Modification Recommended Service Note

P5003B Keysight Streamline Vector Network Analyzer

Serial Numbers: From MY61100009 to MY61100135

Potential lifted front panel overlay

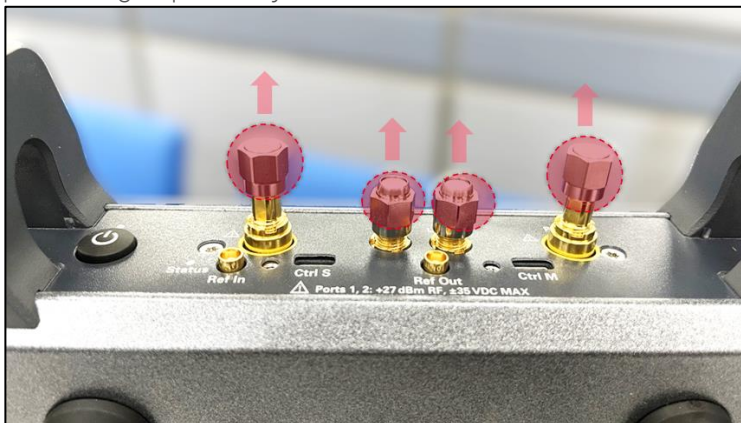
Keysight streamline series vector network analyzer (VNA) of serial number range identified in service note cover page might potentially exhibit the following lifted front panel overlay symptom.

Apart from cosmetic imperfections, the lifted front overlay could have led to non-fully attached *Ctrl S* micro-HDMI cable connector in multi-VNAs setup configuration.

-> Apply this service note only if end users' VNA is exhibiting the following symptom.

Procedure to replace the front panel overlay.

1. Remove the front handles. Detach the 50-ohm termination (LO-In, LO-Out, Port 1 & Port 2) or protecting caps if they are attached to the VNA.

2. Pry open the existing front panel overlay and remove it from front panel.
3. Clean the metal surface thoroughly and ensure it is free of adhesive residue.
4. Affix the new self-adhesive front panel overlay onto the metal surface.
5. Reinstall (reuse) the 50-ohm terminations and port protecting caps accordingly.

6. Reinstall (reuse) the front handles.
